Access Compliance Report

Public Rights-of-Way

Intersection ID: 13587	Main Street: E_HILL_ST	Cross Street: ROYAL_CT	Location:	N
ADA ID: 6EFD64AFD551	Ramp Type: PerpDiag	Initial Pass/Fail: Fail	Overall Compliance: No	Severity Score: 25

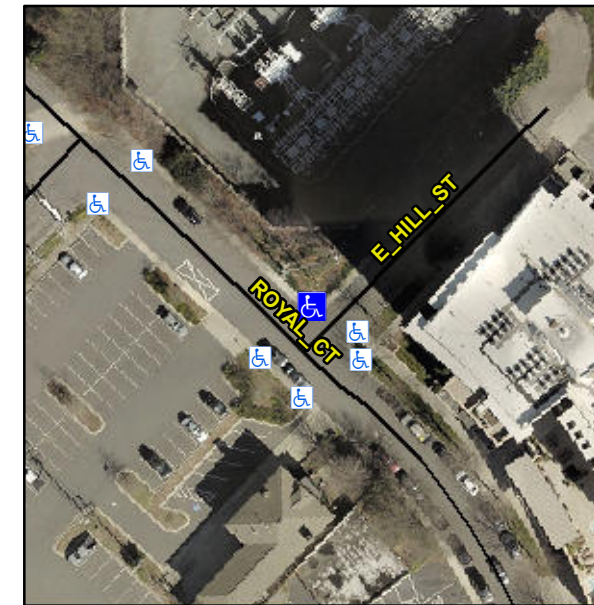
R304.5.3

Compliance	Description	Data	Compliance	Description	Data
N/A	Ramp Length (in)	72.0	Yes	Ramp Slope (%)	7.9
Yes	Ramp Width (in)	48.0	No	Ramp XSlope (%)	12.2
N/A	Flare Type LT	N/A	N/A	Flare Type RT	N/A
N/A	Flare Slope LT (%)	N/A	N/A	Flare Slope RT (%)	N/A
N/A	Flare Traversable LT?	N/A	N/A	Flare Traversable RT?	N/A
N/A	Landing Length (in)	N/A	N/A	DWS Provided?	N/A
N/A	Landing Width (in)	N/A	N/A	DWS Contrast?	N/A
N/A	Landing Slope (%)	N/A	N/A	DWS Length (in)	N/A
N/A	Landing X Slope (%)	N/A	N/A	DWS Full Width?	N/A
N/A	Landing Curb? (Y/N)	N/A	N/A	DWS Offset (in)	N/A
N/A	Shared Landing?	N/A			
N/A	Gutter Ponding?	N/A	N/A	Gutter Slope (%)	N/A
N/A	Gutter Lip Ht (in)	N/A	N/A	Gutter X Slope (%)	N/A
N/A	Painted X Walk1?	No	N/A	Painted X Walk2?	No
	X Walk 1 Direction	To SW		X Walk 2 Direction	To SE
N/A	X Walk 1 Width (in)	N/A	N/A	X Walk 2 Width (in)	N/A
	X Walk 1 Slope (%)	3.5		X Walk 2 Slope (%)	1.3
	X Walk 1 X Slope (%)	5.7		X Walk 2 X Slope (%)	1.9

Remove & Replace Curb Ramp With Two New Directional Ramps or Equivalent.
